EXXON NUCLEAR COMPANY, Inc.

December 10, 1979

ENC COMMENTS ON NRC DRAFT REPORT NUREG-0630
CLADDING, SWELLING AND RUPTURE MODELS FOR LOCA ANALYSIS

FIGURE 1 BLOCKAGE PREDICTION BASED ON CONSIDERING
REDUCED AXIAL EXTENT OF STRAIN

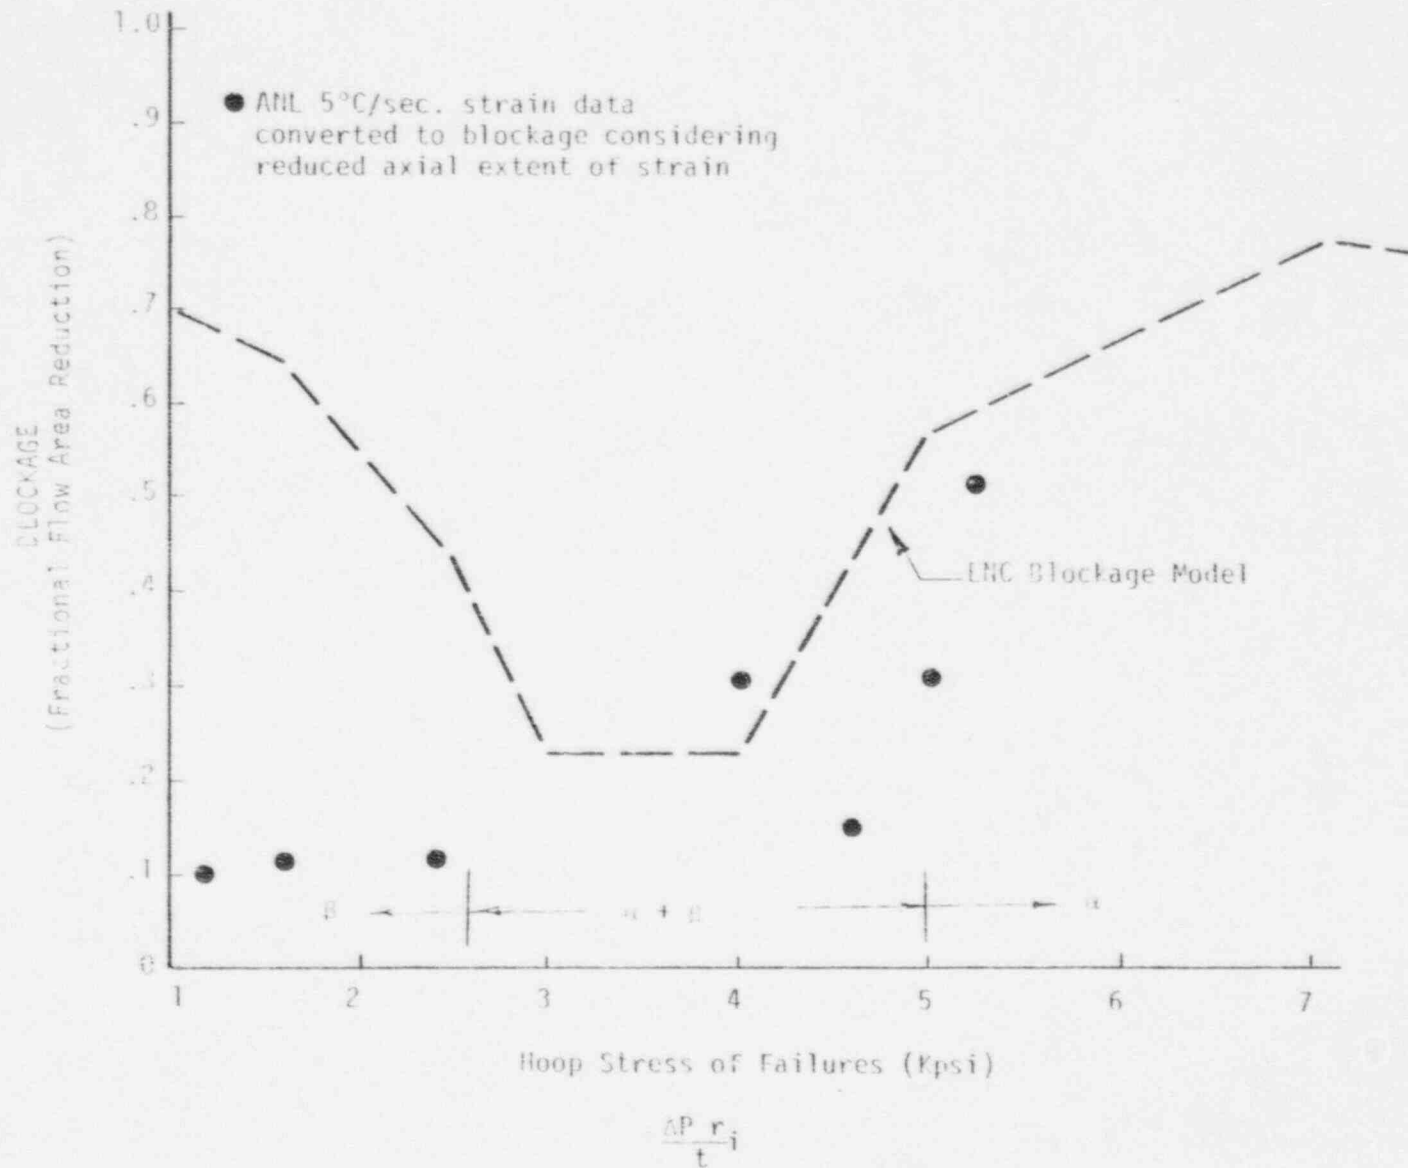
The α to $\alpha + \beta$ region extrapolation method used in reference (a) to create the NRC blockage model only accounted for the effect of reduced ductility in the circumferential direction; the method did not account for the additional reduction in blockage caused by the reduced axial extent of ballooning that also exists in the low ductility region. The reduced axial extent of the ballooned region decreases the coplanar nature of a blockage and, thus, reduces the magnitude of the blockage. Taking the axial extent of the balloon to be reduced in proportion to the circumferential strain implies the blockage would be reduced in proportion to the square of the circumferential strain. This squared rather than linear proportionality is confirmed by the original ORNL data which included multi-rod tests in both the α and $\alpha + \beta$ regions. The ratio of the average blockage in the α and $\alpha + \beta$ regions was .32, while the corresponding average strain ratio was 0.62 and the strain ratio squared was 0.38. Thus, the square of the strain ratio conservatively predicted the $\alpha + \beta$ region blockage from the α region blockage data. Figure 1 shows the low ramp rate blockage predictions (data points) using this squared method. The points shown on Figure 1 represent the key ANL low ramp rate data (5°C/sec) used by NRC to construct the low ramp burst strain and blockage curves in reference (a). The method used to convert this single rod data to flow blockage was identical to that described in reference (a), except that the squared strain method was used to account for the reduced axial extent of blockage. The ENC blockage model is shown in this figure to conservatively represent this key ANL data. Furthermore, the ENC model grossly overestimates the blockage in the β region due to lack of consideration of oxidation effects, and should be revised to be more consistent with the new data taken in a steam environment.

It is ENC's recommendation that the low ramp rate blockage model in reference (a) be revised in the $\alpha + \beta$ and β regions to consider the reduced axial extents of strain that are associated with the $\alpha + \beta$ and β regions as suggested above.
